CONSULTANT ADVICE NOTICE

CHORA – 7 HARTINGTON STREET, NORTHCOTE

WATER SENSITIVE URBAN DESIGN RFI RESPONSES

Date: 26.03.2026
CAN 2.0

Figure 1.0 - Typical Buffer Strip.

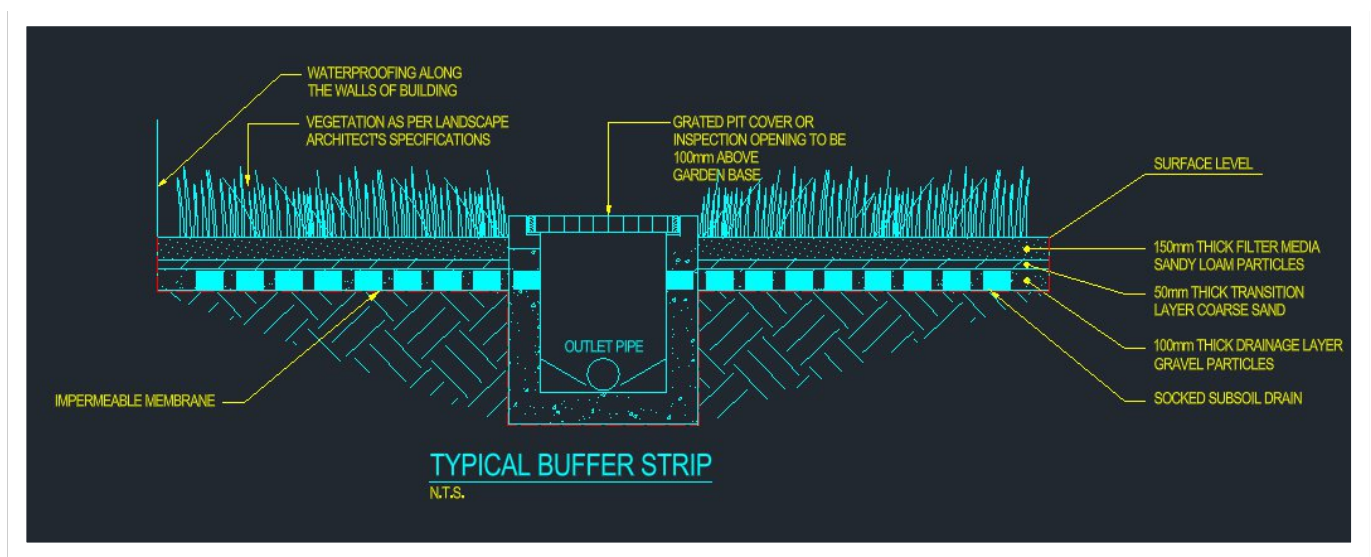
We agree that a single 250m² raingarden is not feasible within the current site constraints. Instead, we propose to break the treatment requirement into multiple smaller raingardens and/or vegetated buffer strips within landscape zones across the site, utilising available setbacks and open space areas.

Figure 2.0 - Rain Garden Location for ELC.

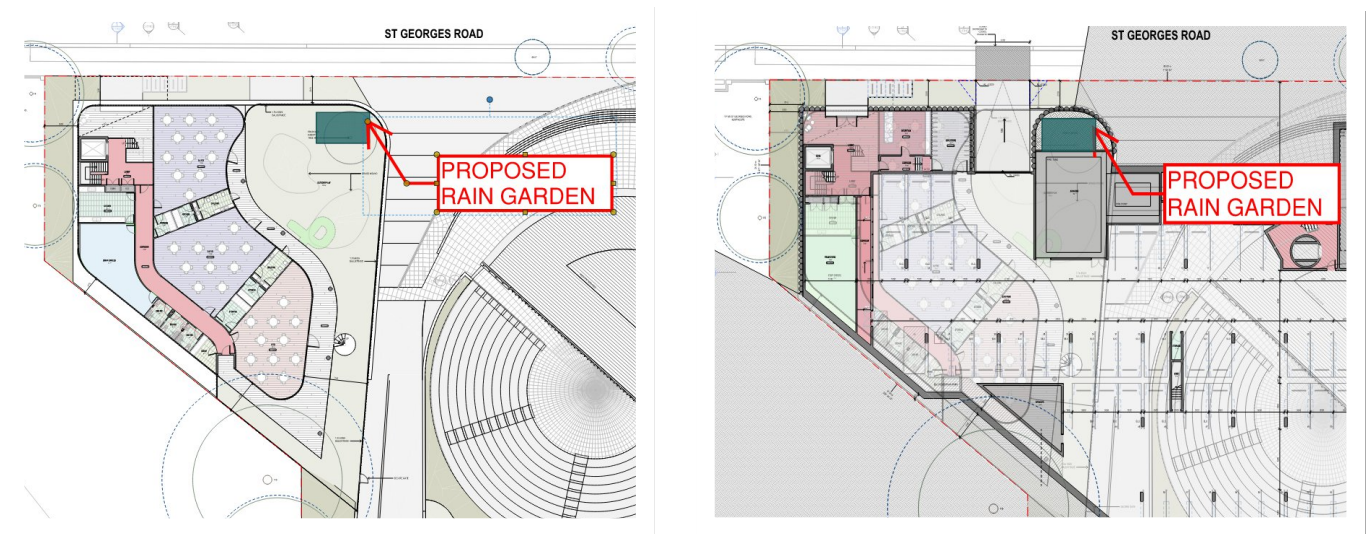
Overall strategy within the SMP is considered appropriate, however requires further breakdown and detailed allocation of treatment areas.

- Roof areas to discharge to the 60kL reuse tank at basement level
- Green roof terrace (Level 2) to discharge to above-ground planter boxes at Level 1.
- Level 1 open space to be directed to a below-ground raingarden, potentially placed in the tree planter area shown in the architectural plans
- *Alternate Option:* Direct both Level 1 & 2 open space to below-ground raingarden placed in the tree planter area shown in the architectural plans.

Figure 3.0 - Buffer Strip Location for Heritage Building.

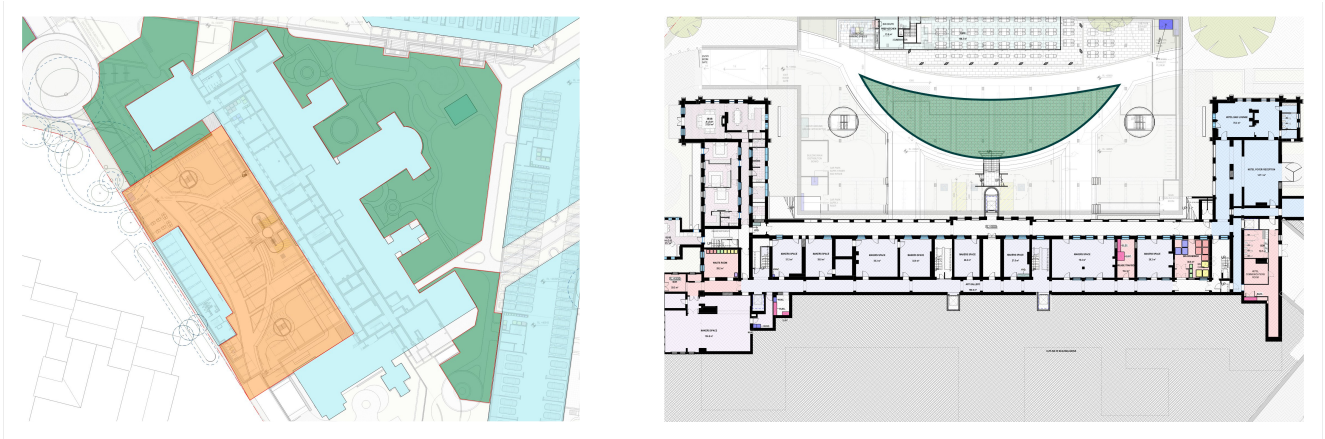
The western courtyard adjacent to the Heritage Building comprises a large impervious hardstand area (approximately 2,200m²), located above basement level.

To provide stormwater treatment within this zone, it is proposed that the area between the Heritage Building and the cafe be designed as a linear buffer strip at lower ground level (Refer to Figure 3.0).

- All surrounding impervious paving is to be graded to direct runoff toward the biofiltration system (no isolated low points).
- The buffer strip will function as a primary treatment element for this catchment.
- Given the area is located directly above the basement, the buffer strip will be designed as a lined treatment system.

- Accommodate treatment depth within the slab.
- Integrate a recessed slab / bulkhead at basement high level
- Water proofing to prevent seepage to basement level.

The proposed linear buffer strip will be sized to treat runoff from the contributing courtyard catchment (~2,200m²), subject to MUSIC modelling

Figure 4.0 - Permeable treatment Areas.

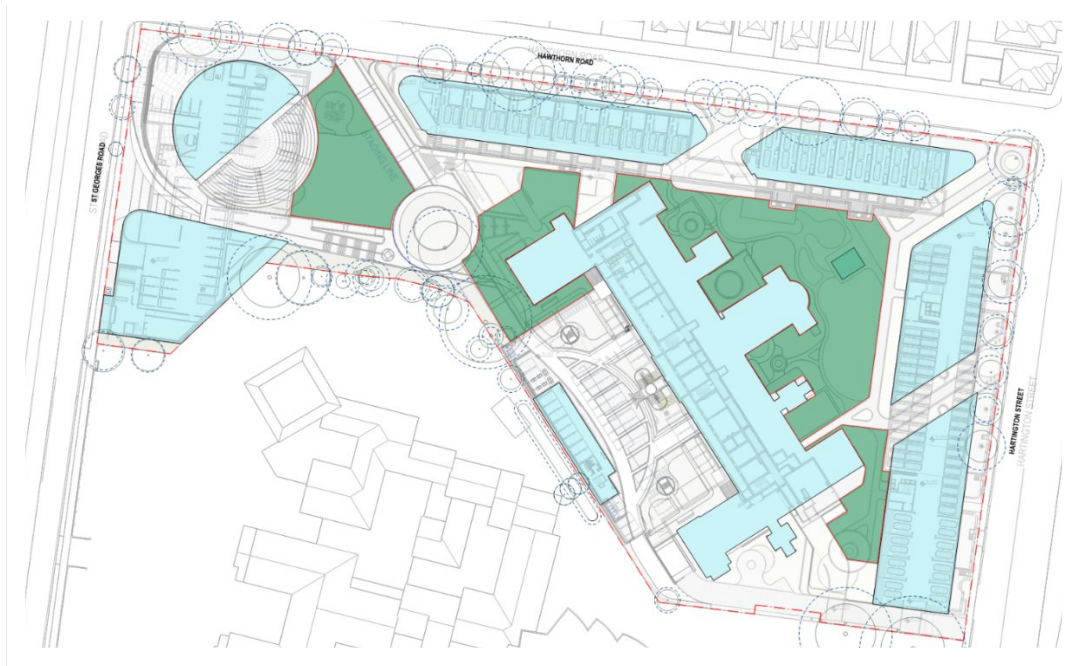
The current extent of impervious surfaces limits the ability to achieve best-practice WSUD outcomes.

- Introducing permeable paving to selected footpath areas. This will reduce directly connected impervious area and improve overall treatment efficiency. Please refer to Figure 4.0 showing indicative permeable treatment areas (to be discussed and coordinated).
- Direct remaining paved areas to adjacent landscape buffer strips for passive treatment.
- Treating POS areas independently via:
 - Raingardens, or
 - Vegetated buffer strips
